CAHILL PLACE SUBDIVISION

Revised for the April 2, 2009 meeting:

DETAIL SITE PLAN

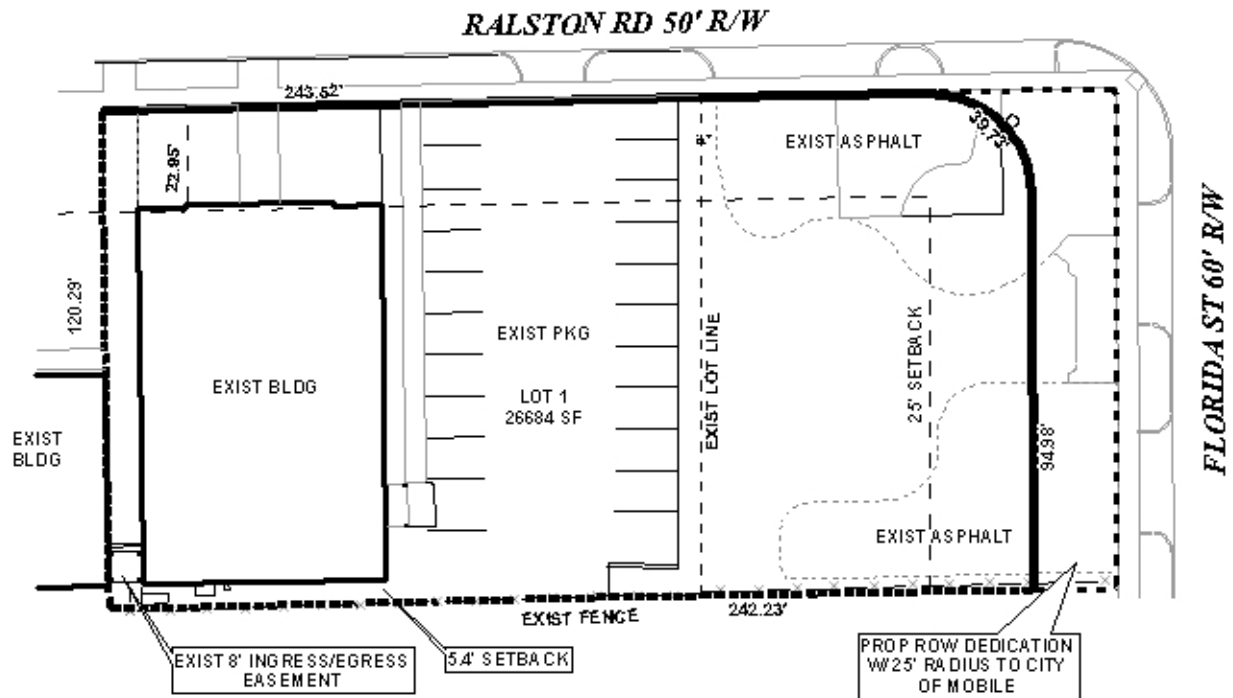
The applicant has submitted a preliminary plat illustrating the removal of the second-story connecting structure, provision of dedication of the minimum 50-foot as measured from the centerline of Florida Street and the provision of adequate radii at the intersection of south Florida Street and Ralston Road. However, conditions of limiting of the curb cuts to allow one curb cut each to South Florida Street and Ralston Road have not been indicated on the preliminary plat, the placement of a note on the Final Plat stating that the development is limited to one curb cut to Ralston Road and one curb cut to South Florida Street, with the size, location, and design to be approved by Traffic Engineering and conform to AASHTO standards.

- 1) *revision of the 25-foot minimum building line to show the minimum building line along all street frontages;*
- 2) *dedication of sufficient right-of-way, South Florida Street, to provide a minimum 50-feet as measured from the centerline of South Florida Street;*

- 3) *placement of a note on the Final Plat stating that the development is limited to one curb cut to Ralston Road and one curb cut to South Florida Street, with the size, location, and design to be approved by Traffic Engineering and conform to AASHTO standards;*

- 4) *provision of adequate radii, in compliance with Section V.B.16. of the Subdivision Regulations, at the intersection of South Florida Street and Ralston Road, with the size to be determined by Traffic Engineering and conform to AASHTO standards;*

- 5) *the placement of a note on the Final Plat, stating that any existing curb cuts not allowed by this subdivision be removed and curbed to City standards, prior to the signing of the Final Plat; and*

- 6) *the submission and approval of the demolition permit to remove the second story building connection between the building on this site and the adjacent building, prior to the signing of the Final Plat.*
